# AURIX™ TC37xEXT errata sheet

**Marking/Step: (E)ES-AB, AB**

10468AERRA

**Figure 1** Message buffer transfer from Message RAM to OBF

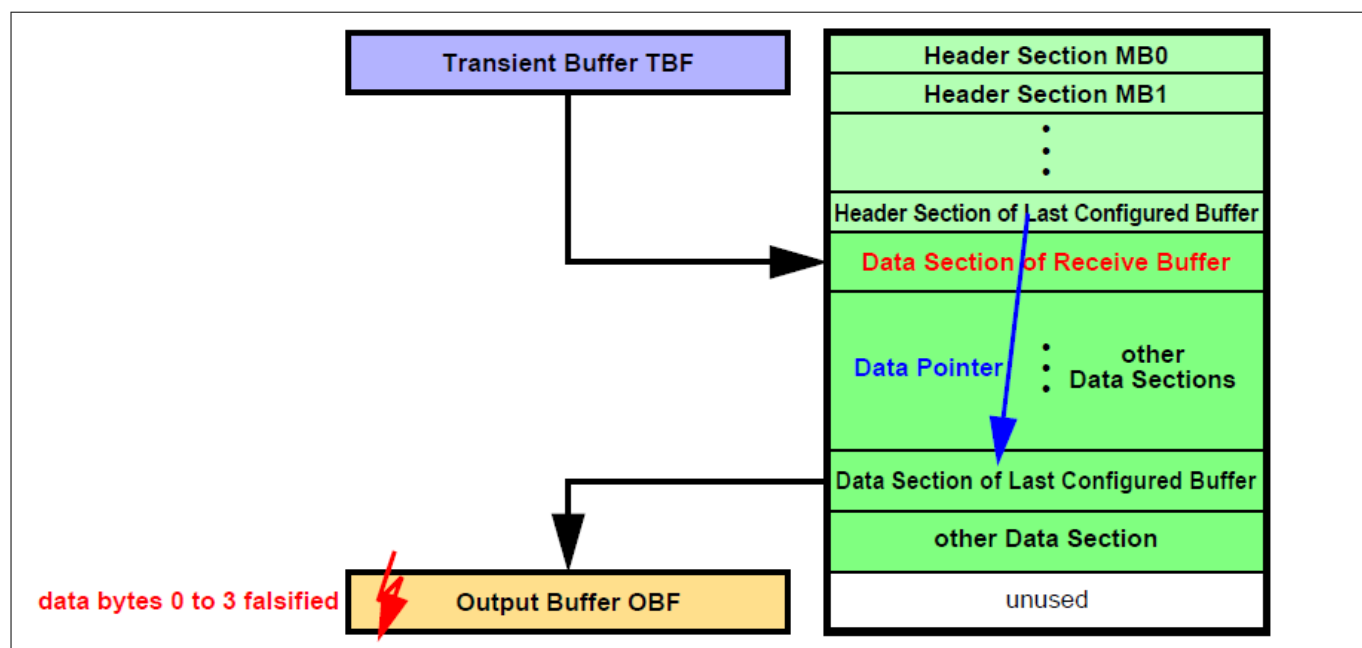
a) When a message is transferred from the Last Configured Buffer in the Message RAM to the OBF and PLC = 127 it may happen, that at the end of the transfer the OBF word on address 00h (payload data bytes 0 to 3) is overwritten with unexpected data (see [Figure 1](#))

**Figure 2** Message buffer transfer from IBF to Message RAM

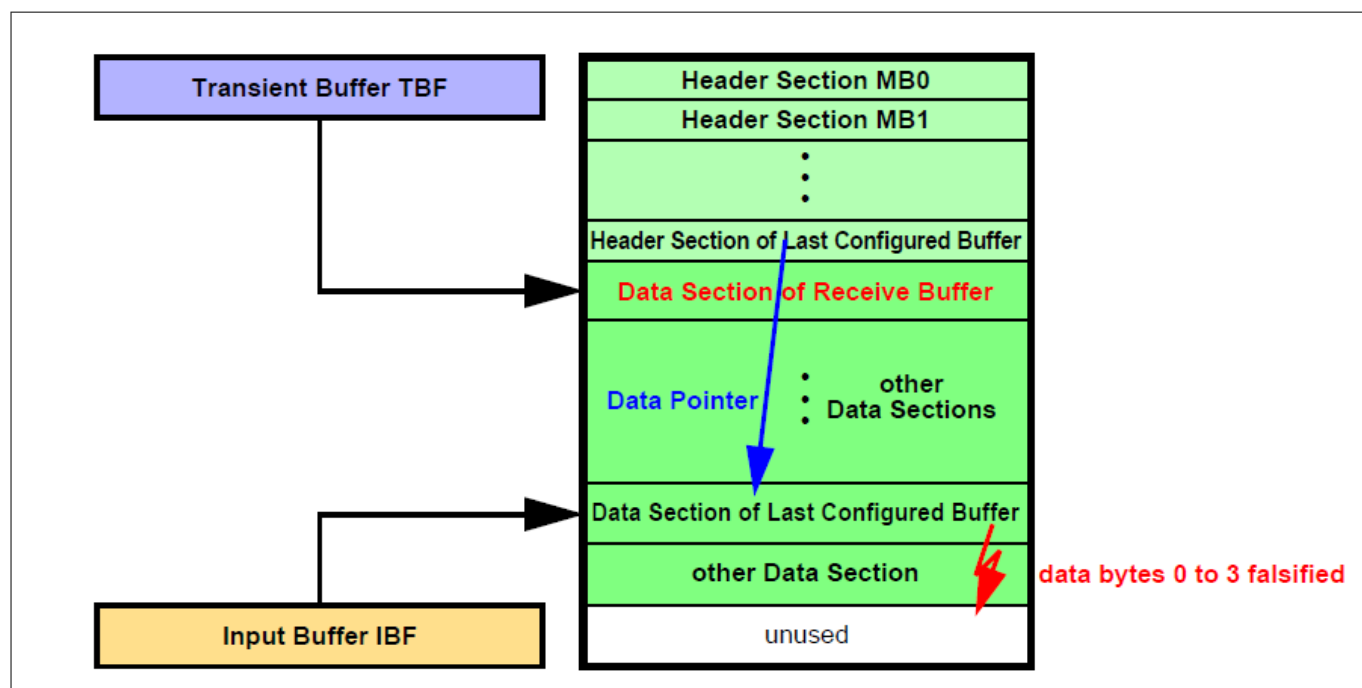
b) When a message is transferred from IBF to the Last Configured Buffer in the Message RAM, it may happen, that at the end of the transfer of the Data Section one additional write access overwrites the following word, which may be the first word of another message's Data Section in the Message RAM (see [Figure 2](#))

**Figure 3** Message RAM configurations

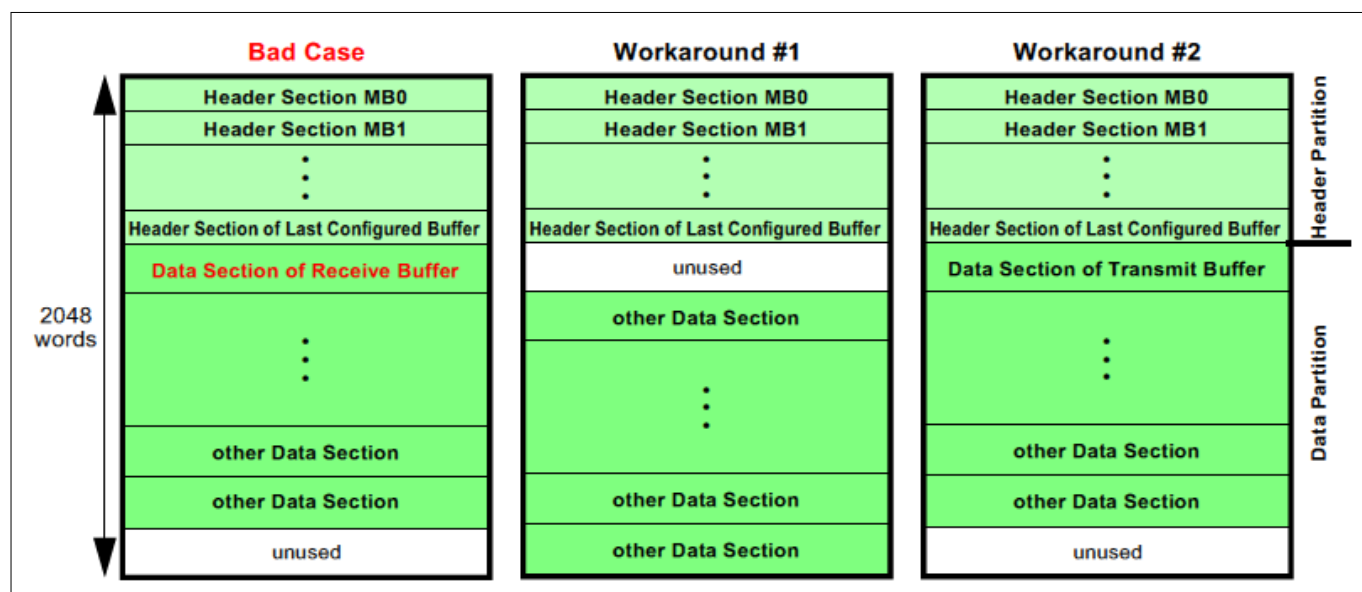
The erratum is limited to the case when (see [Figure 3](#) “Bad Case”):

Ensure that the Data Section directly following the Header Partition is assigned to a transmit buffer.

**Figure 6 Critical MCS AEI master scenario**

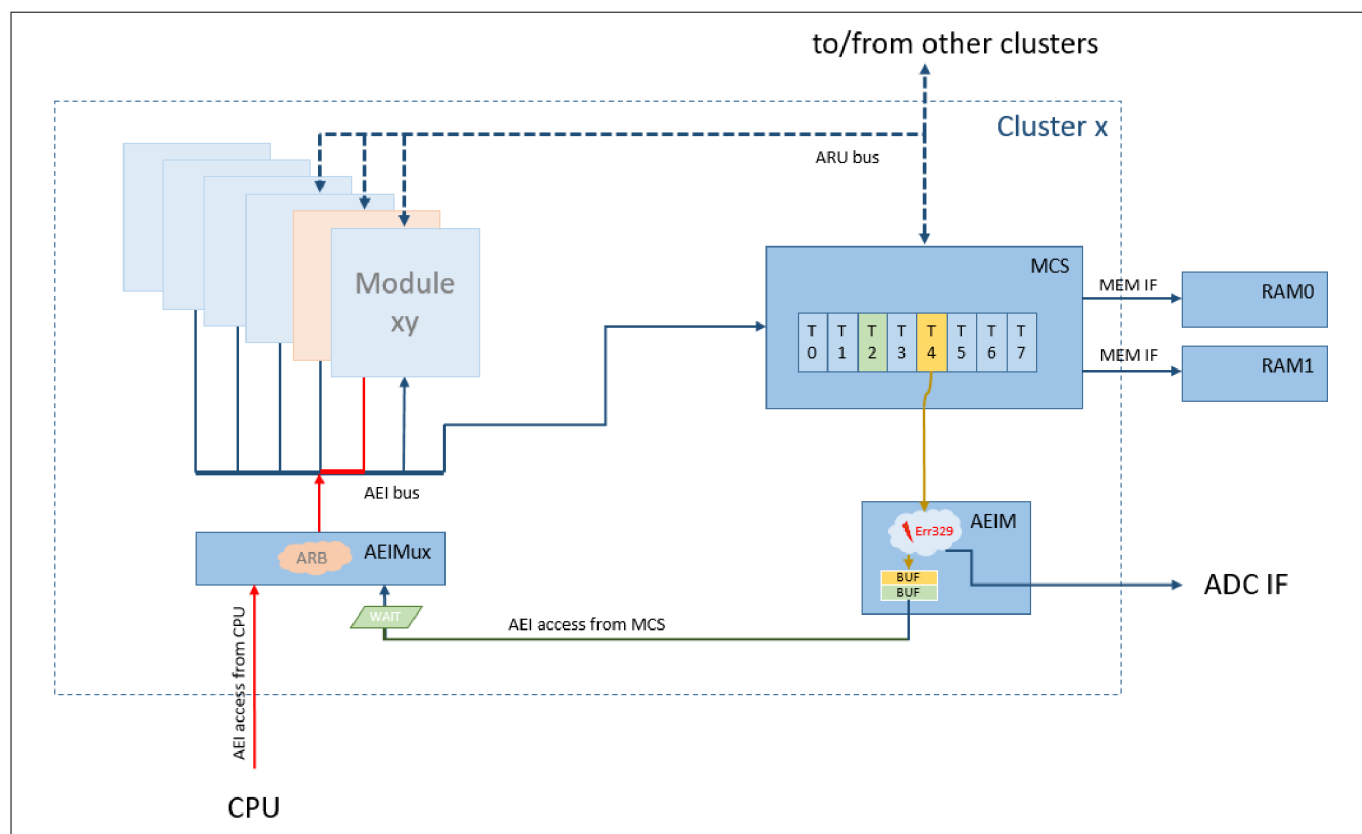
In [Figure 6](#), a potential risk for the occurrence of problem GTM\_AI.329 is illustrated. Here the first buffer of the AEIM (green) is still waiting for the access to the AEI bus while a second AEI bus access from MCS arrives at the AEIM (yellow access path). Under certain, but for the user unpredictable timing conditions, this second AEI bus access arriving at the AEIM can trigger the misbehavior described in problem GTM\_AI.329.

The workarounds described in the 'Workaround' section will ensure that not more than one AEIM buffer will be filled and therefore the occurrence of problem GTM\_AI.329 is avoided. All workarounds have been tested and proven correct.

**Figure 13 Timing of LVDS TX interface command sending in relation to IRQ.IFCFS**

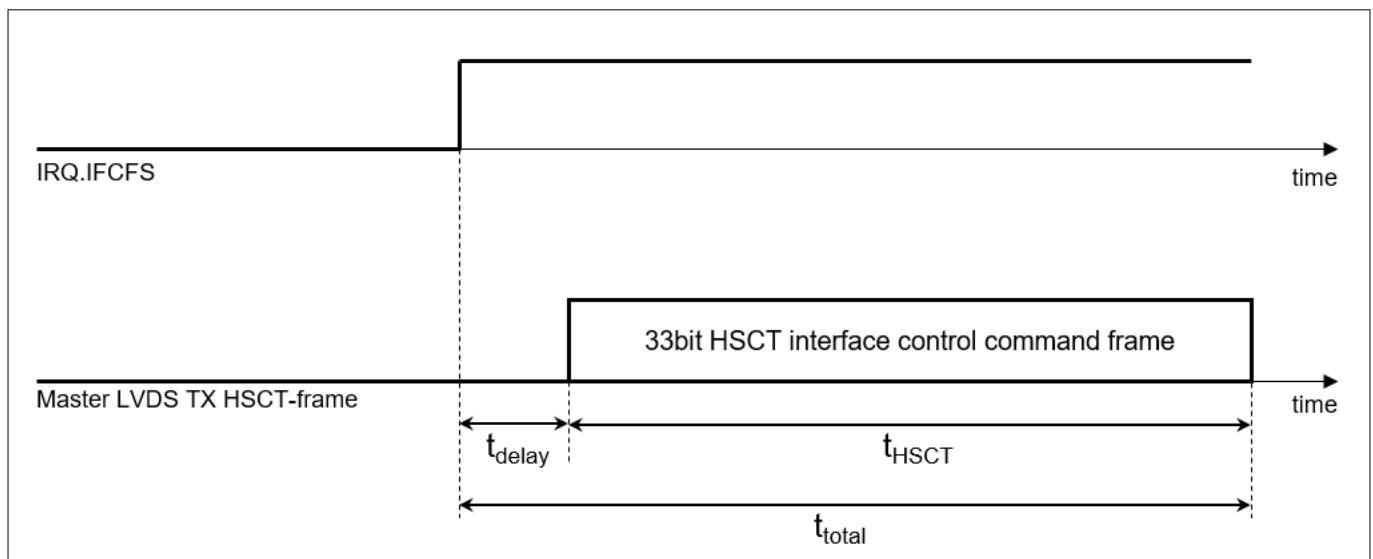
the user might falsely assume that also the actual sending on the LVDS TX port has already occurred once the IRQ.IFCFS flag is set, which is not true.

Instead the timing shown in the following figure applies.

**Figure 14** Package Outlines LQFP-176 for TC37xEXT

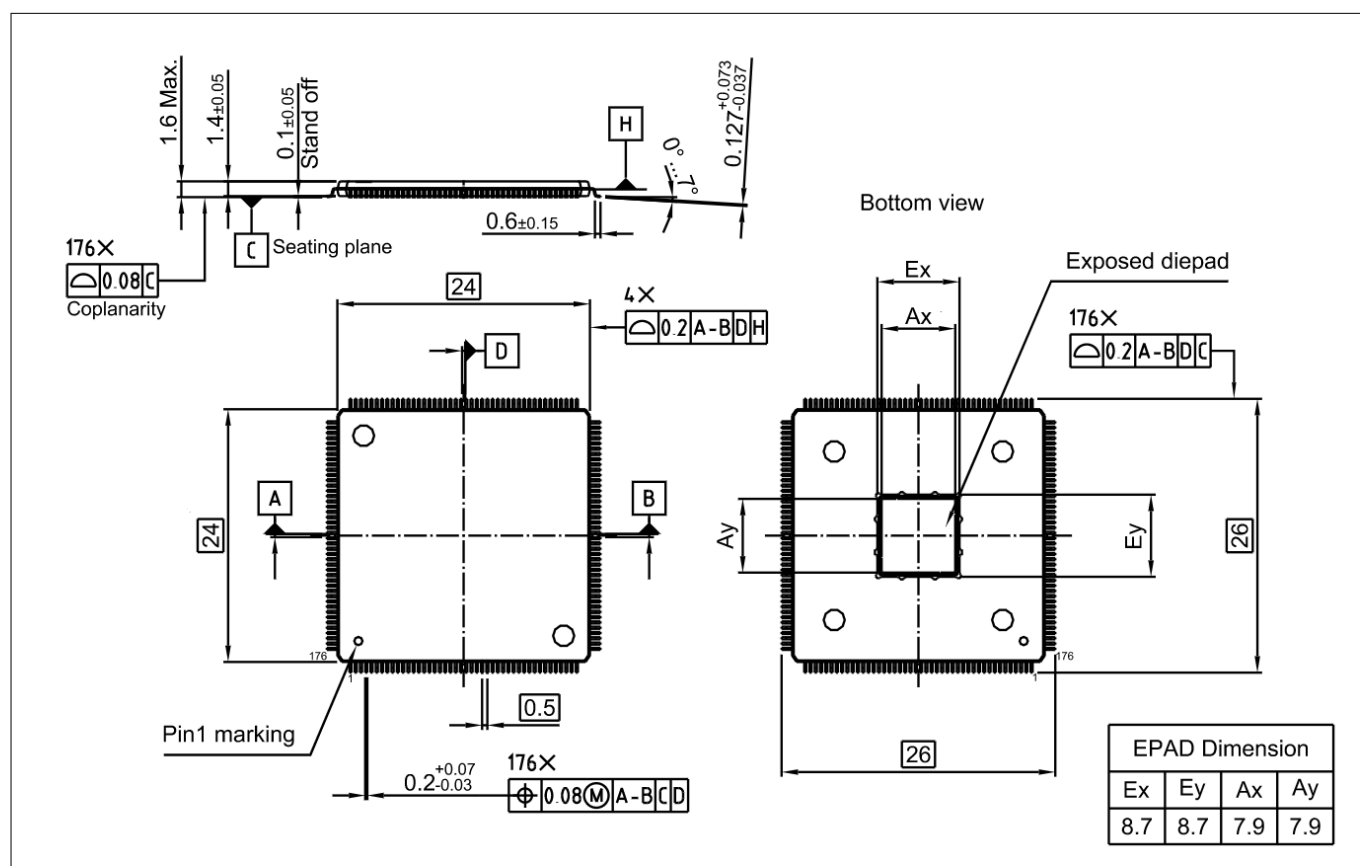
Furthermore, for the exposed die pads, the maximum boundary of the structural corner protrusions to be considered during system design and integration has been added.

**Note:** For the exposed diepad of the LQFP-176 package of the TC37xEXT, structural corner protrusions have to be considered for purposes of system design and integration with a maximum boundary of 9.4 mm.

This information shall substitute the corresponding information in the TC37xEXT AB-step Data Sheet V1.1.

**Figure 15** Package Outlines LQFP-144 for TC37xEXT

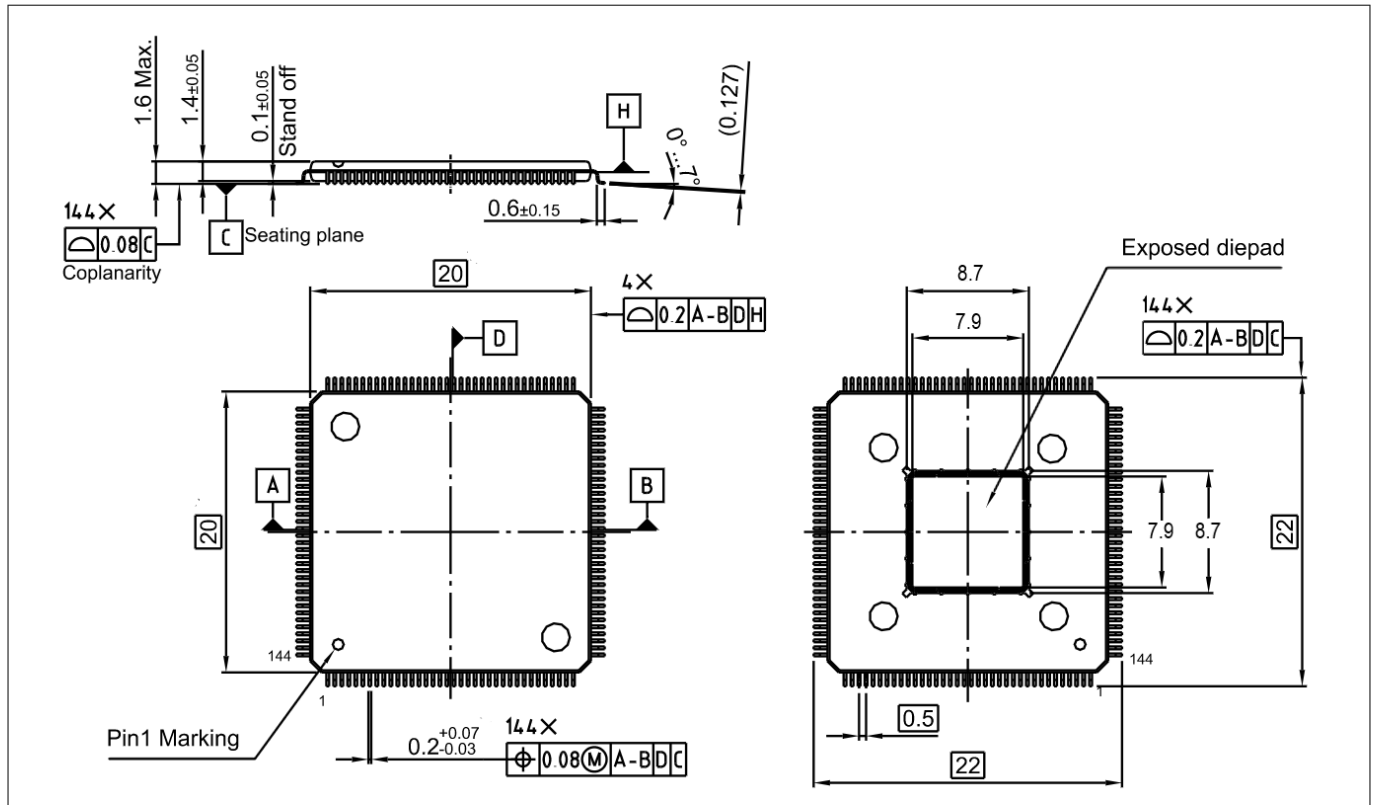
**Note:** For the exposed diepad of the LQFP-144 package of the TC37xEXT, structural corner protrusions have to be considered for purposes of system design and integration with a maximum boundary of 9.4 mm.
